# Addendum No. 2

**PROJECT:** Vivie Nelson Care Center Renovation, Alexandria, MN

**From:** Wold Architects and Engineers

**Subject:** Addendum No. 2 for Bidding Documents for the
**Vivie**
**Nelson Care Center Renovation**
**Alexandria, Minnesota**

# A5.102

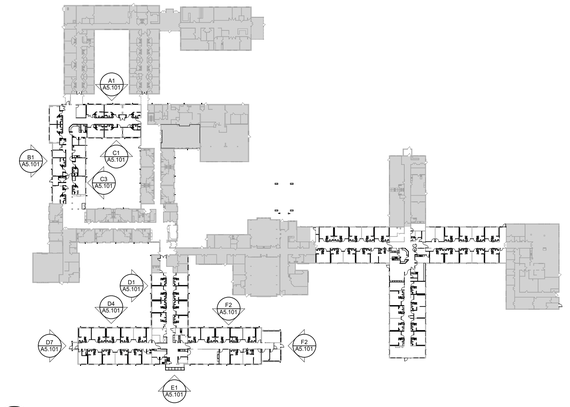
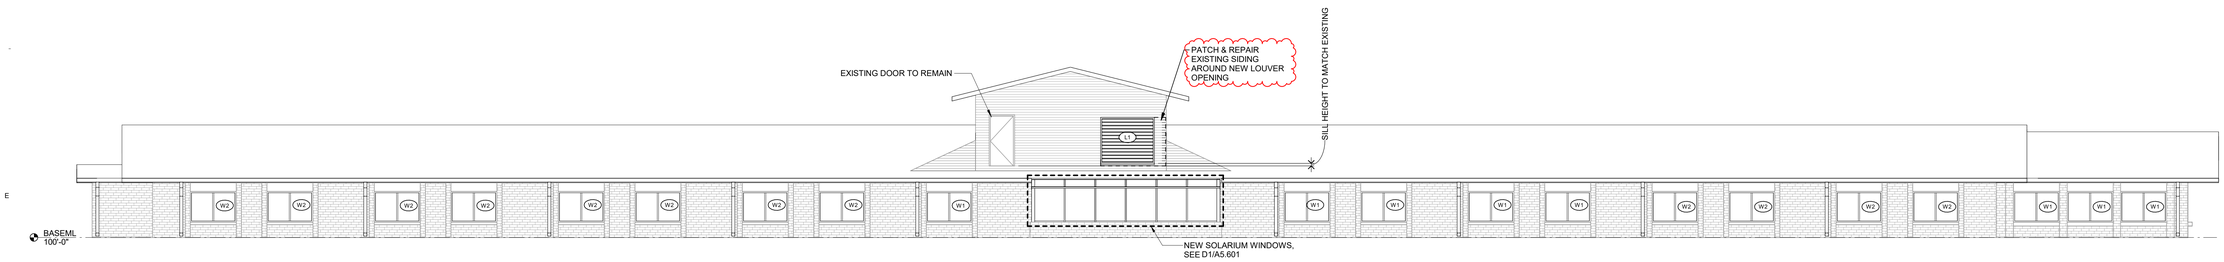
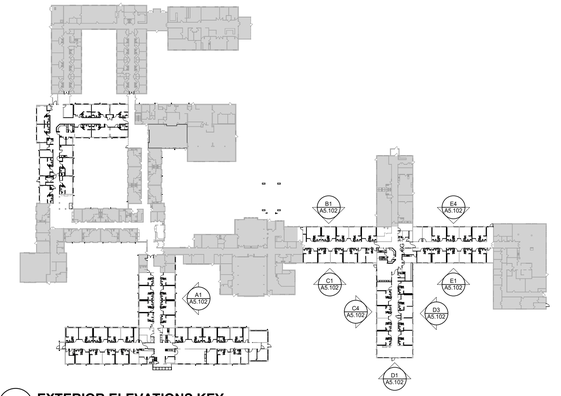
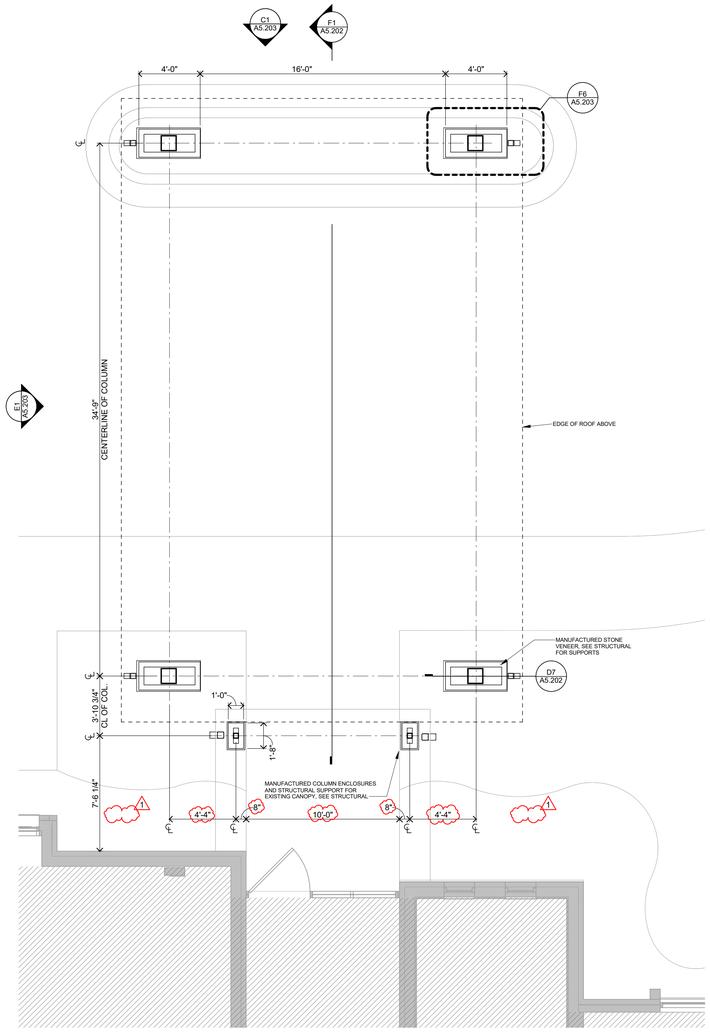
22. **DRAWING A5.102 – EXTERIOR ELEVATIONS**
   A. **Reissued this addendum.**
      i. Clarifications to window and louver types as indicated
      ii. Clarifications to siding scope as indicated

**D1** FIRST FLOOR PLAN - FRONT CANOPY
1/4" = 1'-0"
0 3' 6'

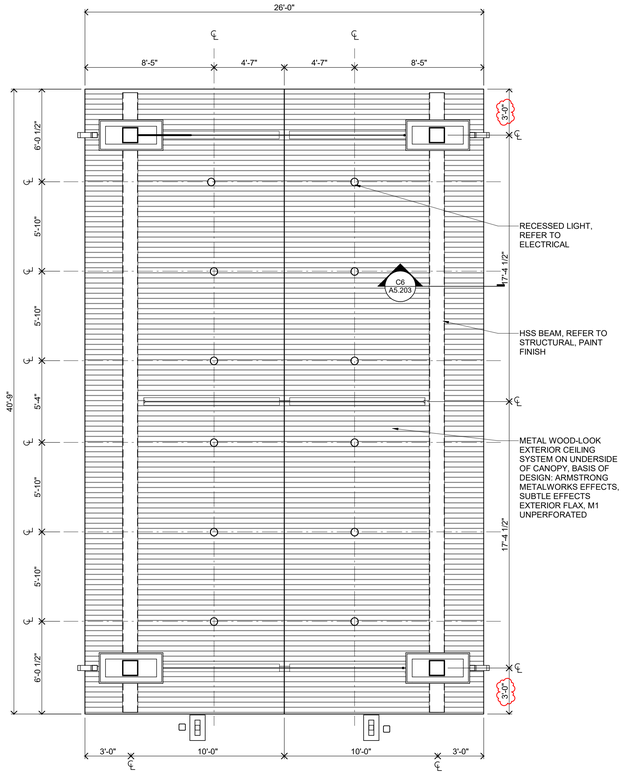
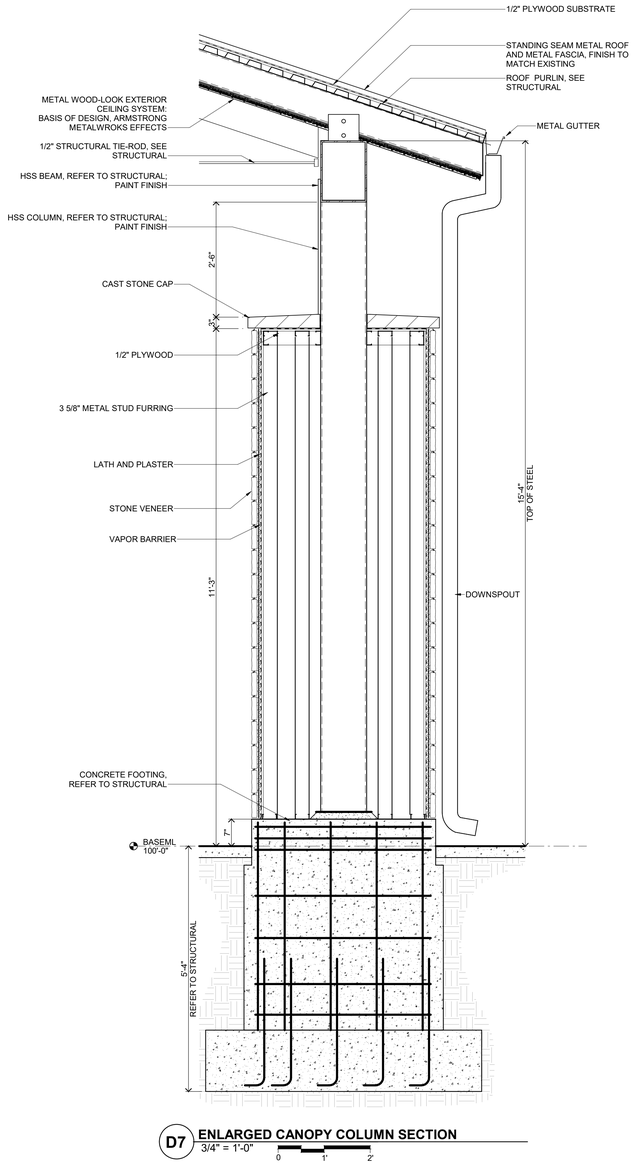
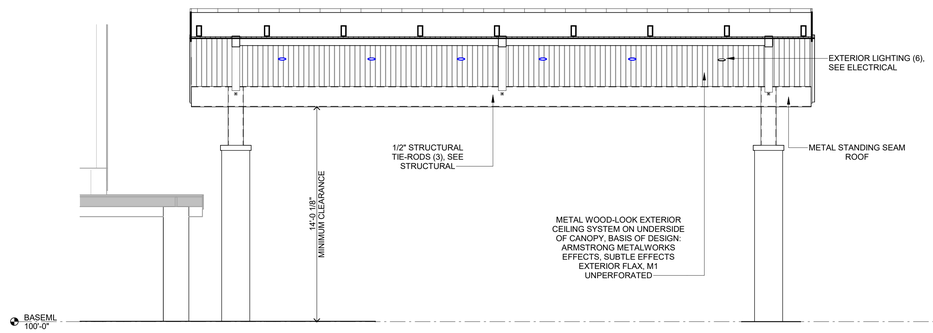
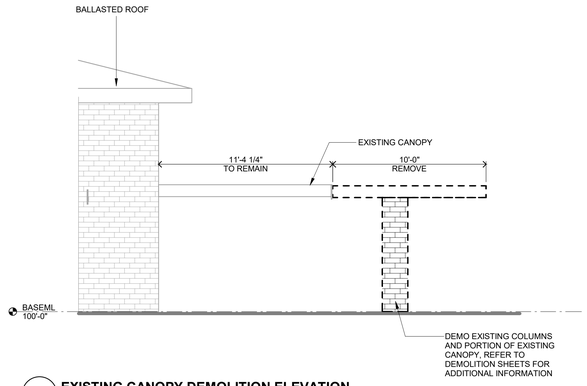
23. **DRAWING A5.202 – EXTERIOR CANOPY**
   A. **Reissued this addendum.**
      i. Dimensions revised as shown.
24. **DRAWING A5.601 – DETAILS – EXTERIOR OPENINGS**

# M3.02a

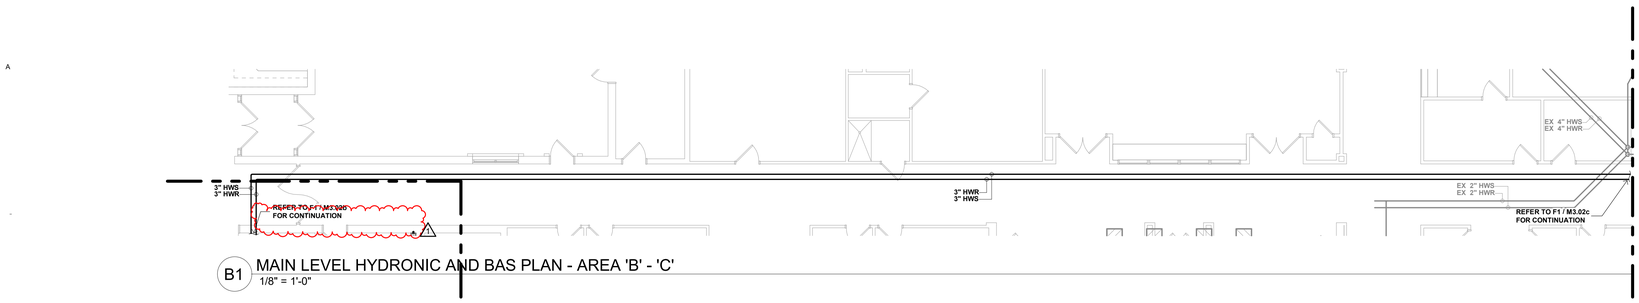
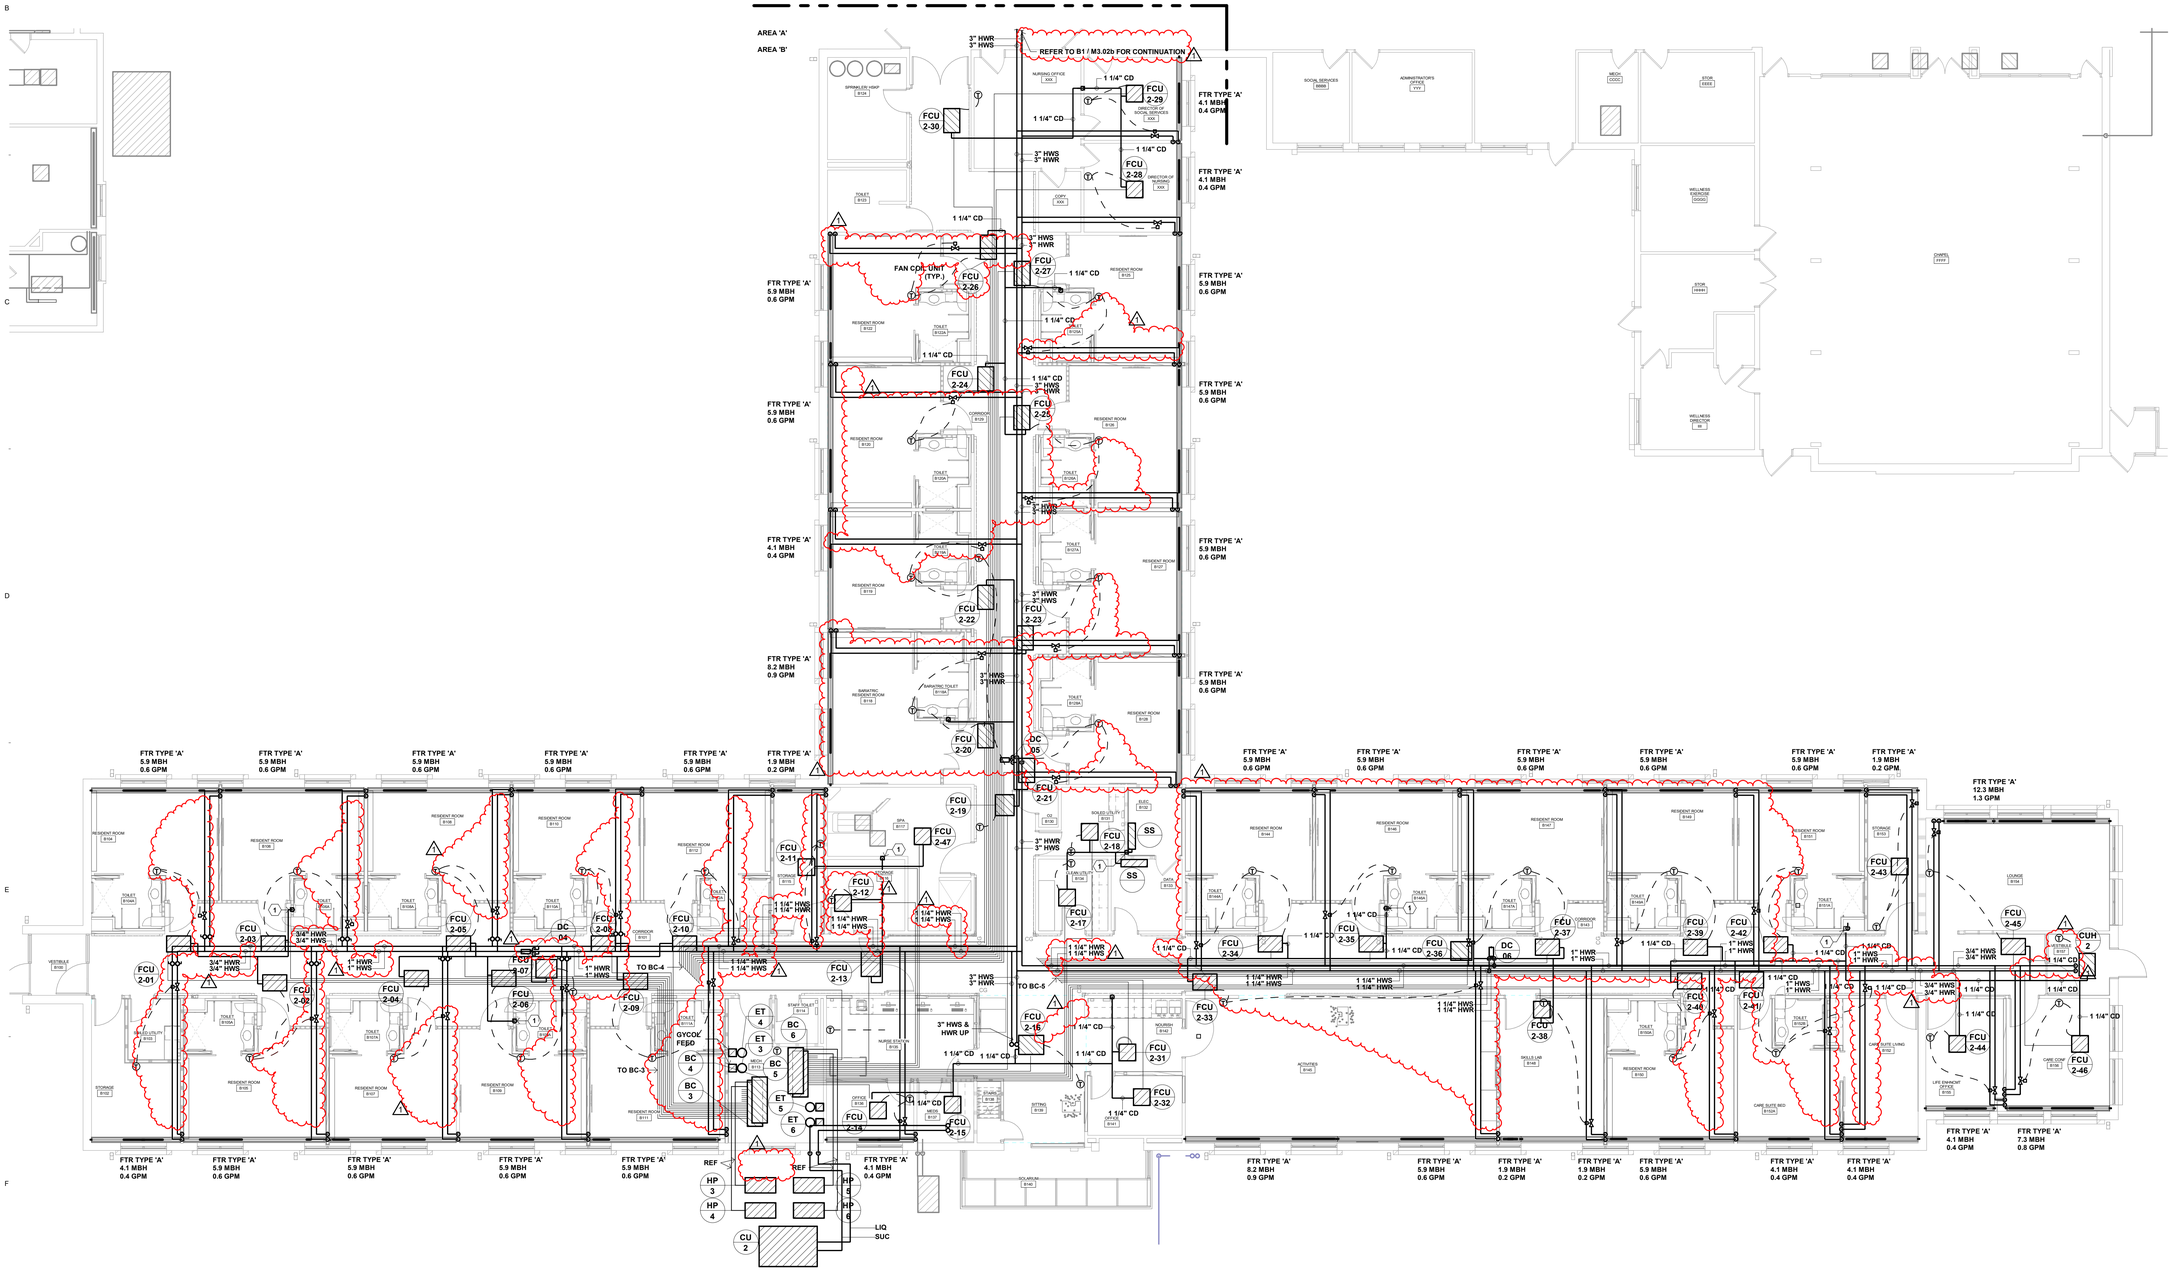
A. **Reissued this addendum**
      **i.** Revised hydronic piping sizing and added drops to duct coils and CUHs**.**
27. **DRAWING M3.02b - MAIN LEVEL HYDRONIC AND BAS PLAN - AREA 'B'**

**MAIN LEVEL HYDRONIC AND BAS PLAN - AREA 'B'**

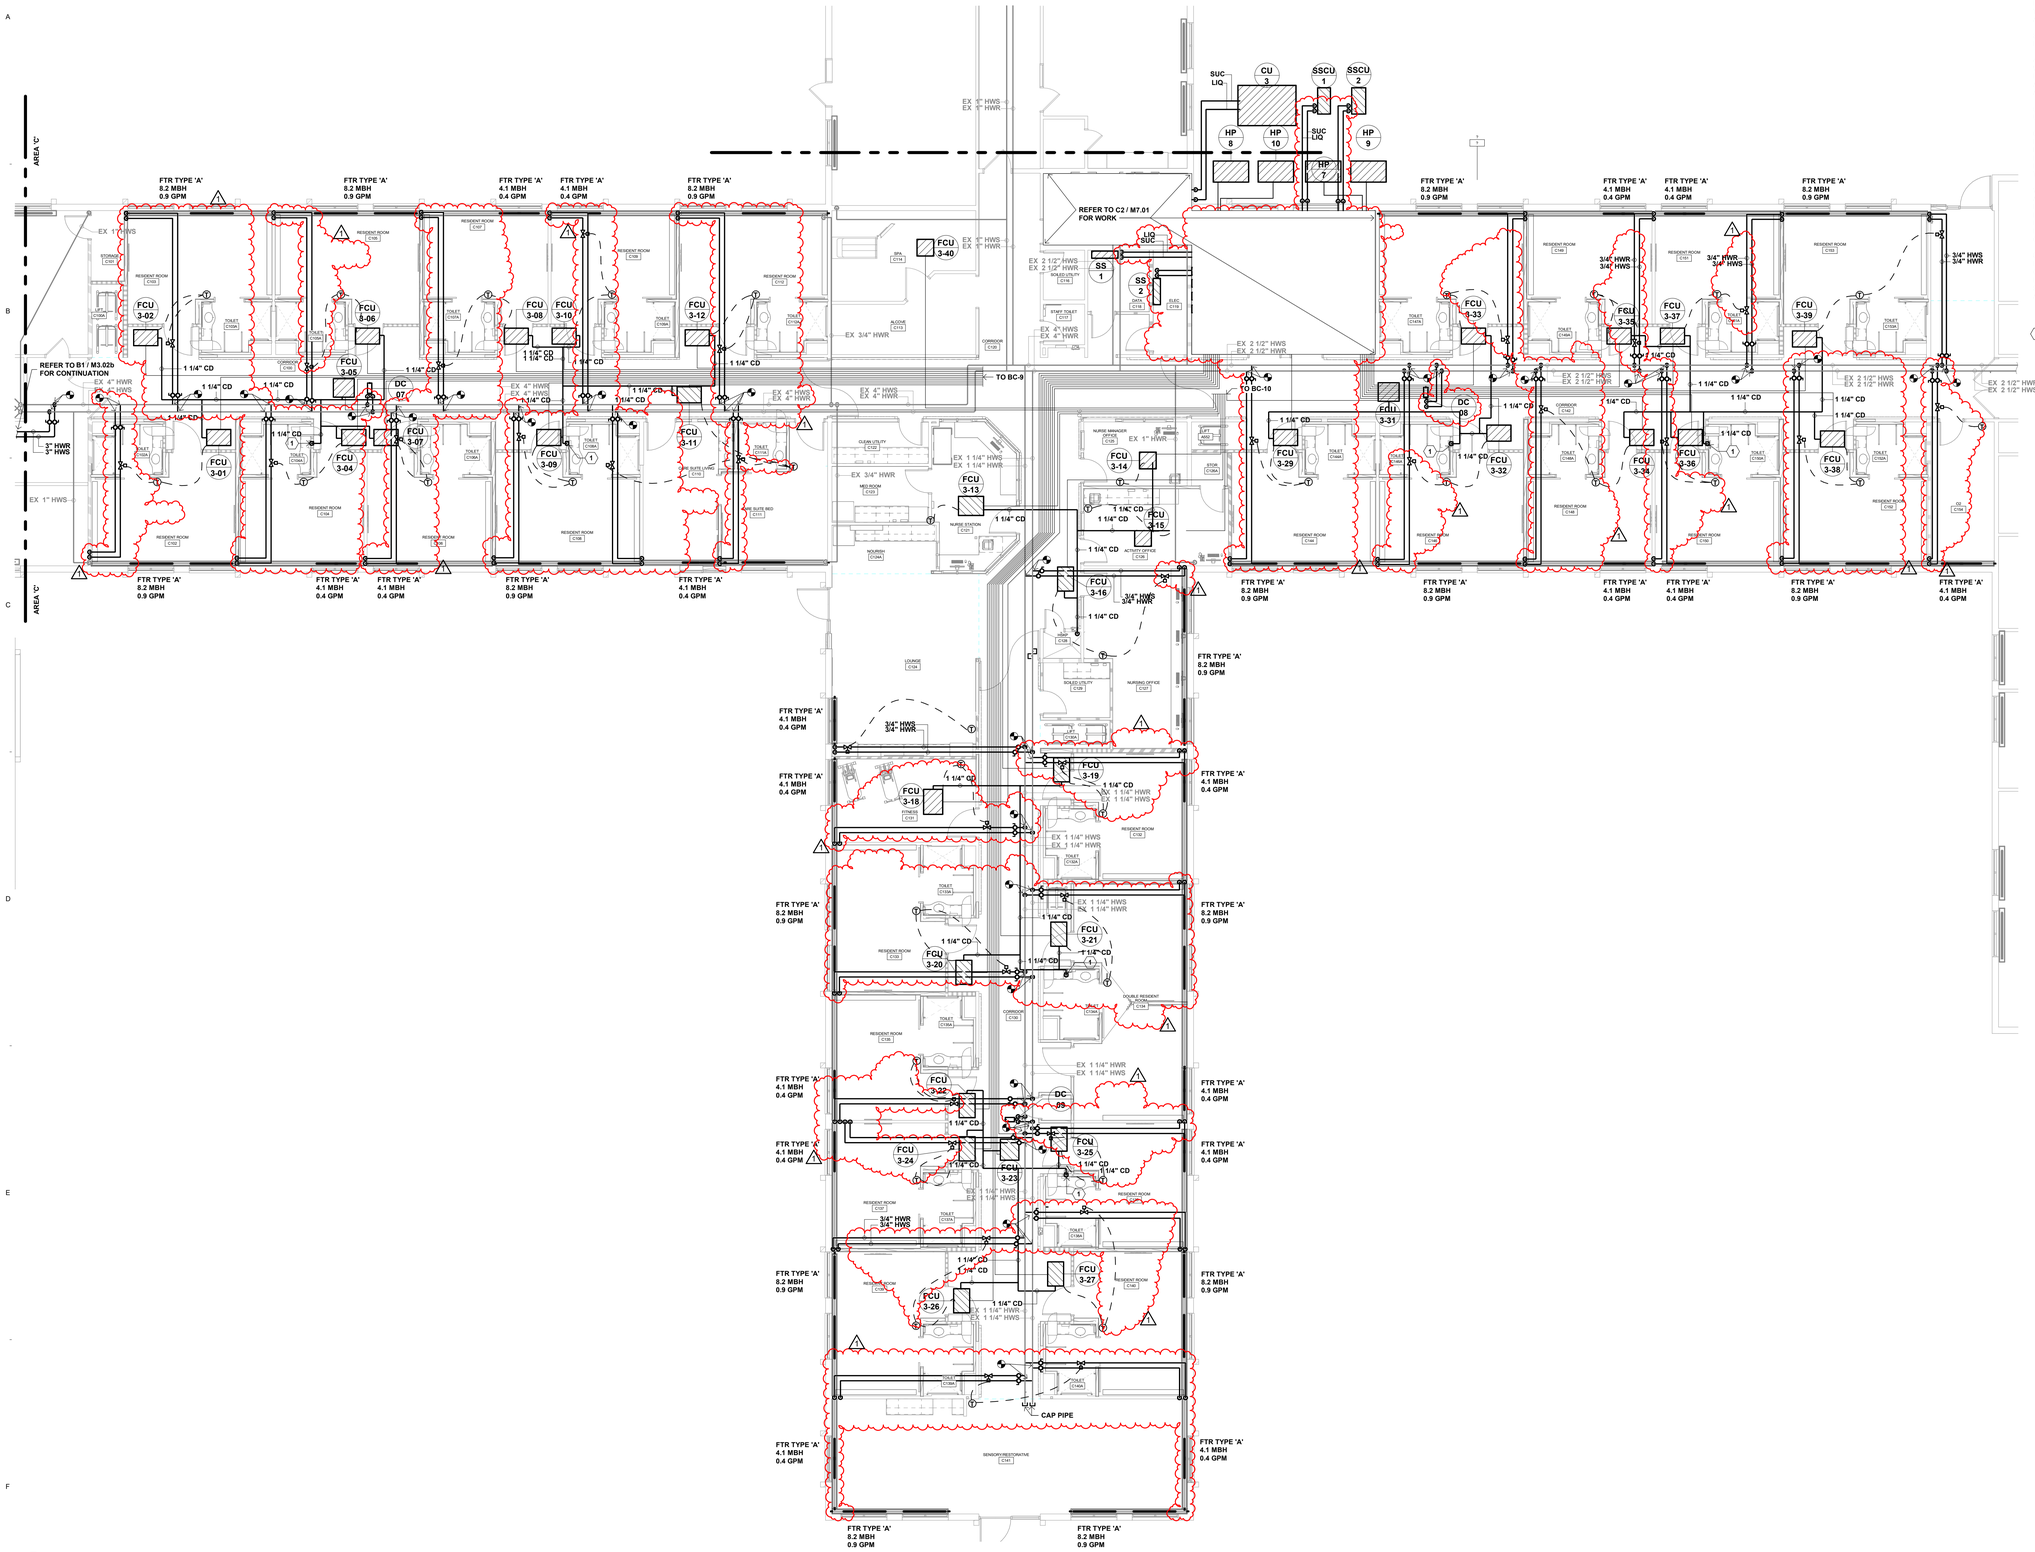
A. **Reissued this addendum**
      i. Revised finned tube piping layout, control valve locations, and updated overall hydronic sizing.
28. **DRAWING M3.02c - MAIN LEVEL HYDRONIC AND BAS PLAN - AREA 'C'**
